**STATE SIGNIFICANT DEVELOPMENT ASSESSMENT:  
YASS VALLEY WIND FARM  
(SSD08\_0246)**

**Secretary's Environmental Assessment Report  
Section 79C of the  
Environmental Planning and Assessment Act 1979**

**January 2015**

**Figure 6.M8 – Looking towards the west**

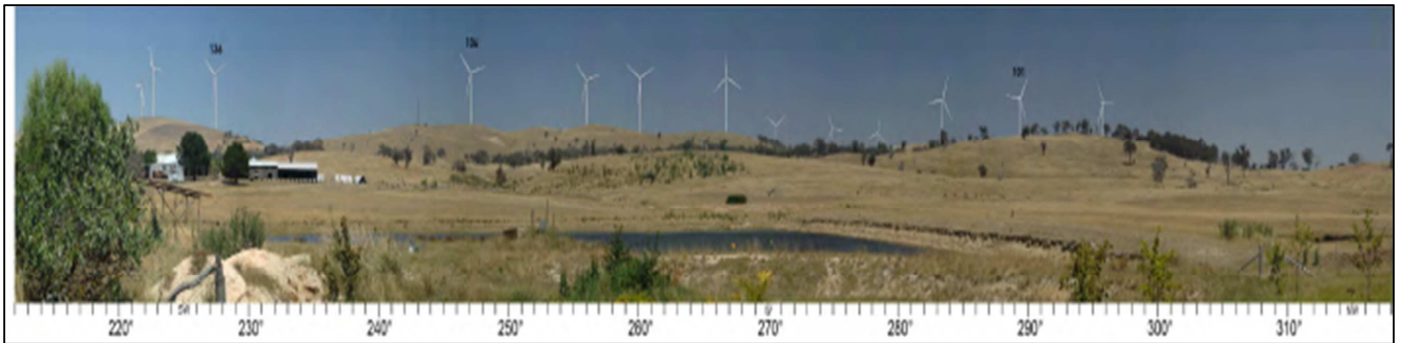
- M8 – this property is occupied by the Crisp Galleries, a business which makes use of its outdoor areas for a range of functions such as wedding ceremonies. The closest turbine is about 2.3km away. The Applicant's assessment concluded that there would be negligible to medium impact because of existing screening. There are a large number of turbines in the backdrop to this property (refer **Figure 5** and **Figure 6**) resulting in views from the property being dominated by the Proposal. A number of these turbines will also have an adverse impact on other properties including G14, M20 and M24 for the reasons identified above. On the basis of these cumulative impacts, the Department concludes that turbines 131,133,134,136 and 100-106 are unacceptable, consistent with the recommendations of the independent report;

**Figure 7. C67 – looking towards the north west**

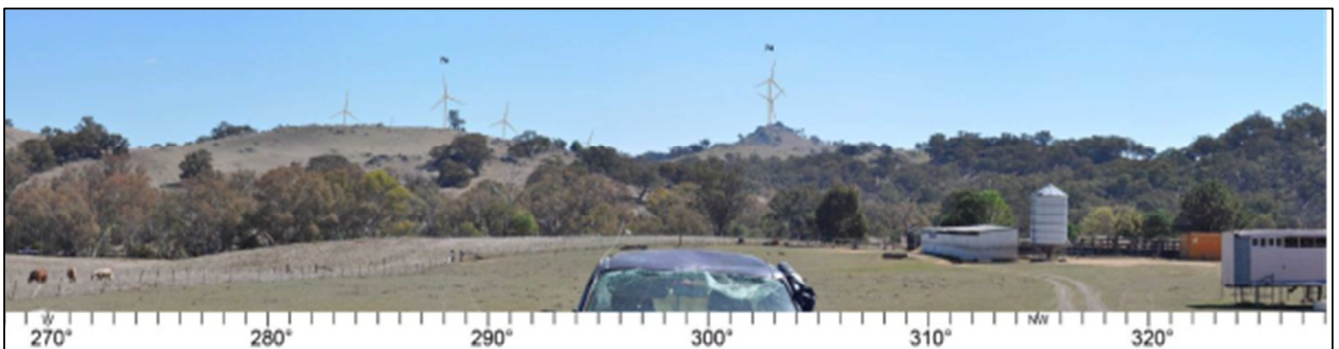
- C67 – this property is located further away from the turbines, with the closest being about 3.2km away. The Applicant considers there will be a medium to high impact. Although the turbines are at a greater distance than some other properties, this property is effectively in an amphitheatre, which means that it would be surrounded by turbines on three sides. In addition, the ridge to the north west of this property has a prominent and scenic rocky knoll that would be impacted by turbines (refer to Figure 7 and Figure 8). The deletion of 10 turbines by the Applicant will reduce some of the visual impacts. However, the Applicant has not updated its photomontages and it is not possible to clearly identify which turbines have been removed, and whether this impact is now acceptable. Regardless, the impacts to the north west remain a concern.

**Figure 9: construction traffic access routes (as indicated in the Applicant's traffic impact study)**

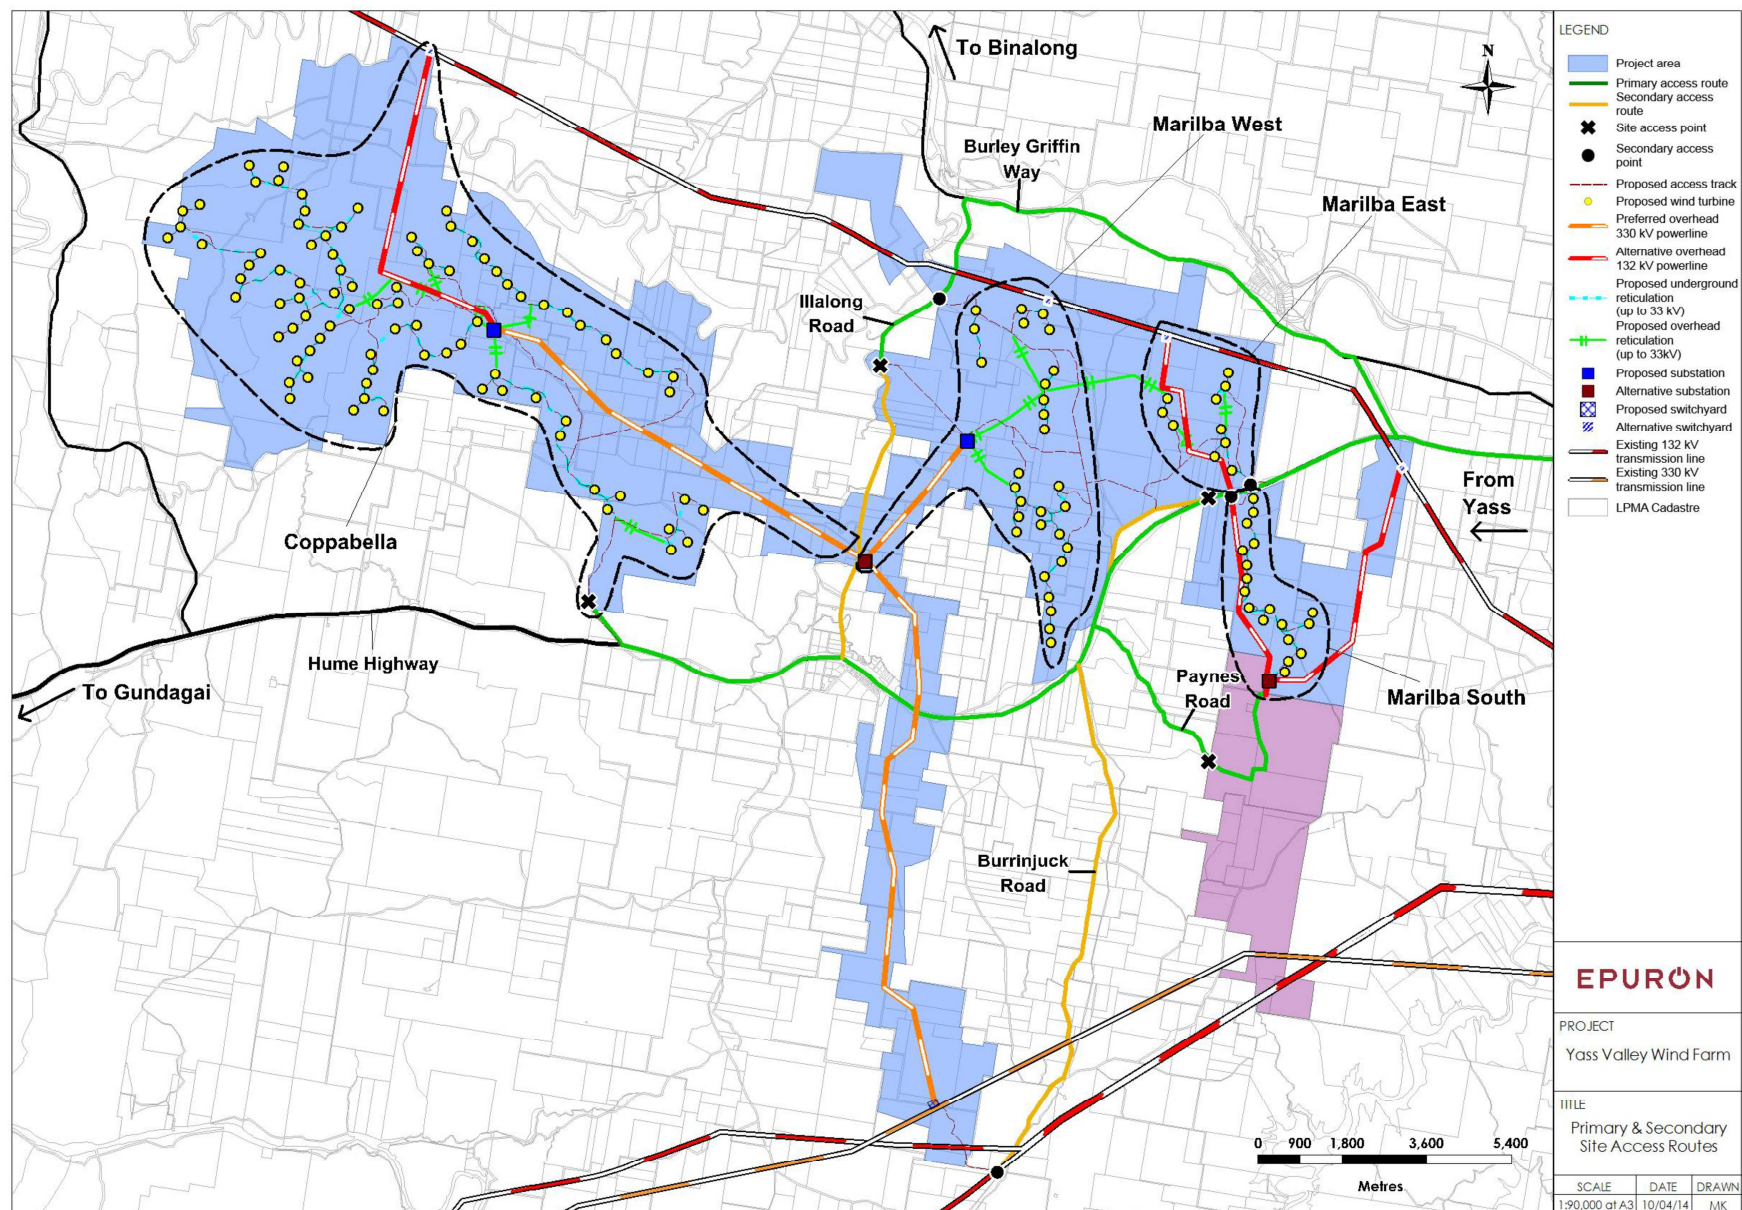
The primary and secondary access points into the Coppabella and Marilba precincts for the movement of construction vehicles are detailed in **Figure 9** (which have been updated in Section 7 in the final Preferred Project Report but not reflected in the Applicant's Traffic Impact Study and associated traffic access route map). The Department is therefore unsure on the final location of some access points.

The Department notes that the Applicant has provided a revised primary and secondary site access route map within Section 7 of its final Preferred Project Report. The Report indicates that there may be 2 primary access points to access the Marilba West Precinct. The Department also notes that the Applicant's Traffic Impact Study has not assessed the impacts of these 2 access points into the Marilba West Precinct.
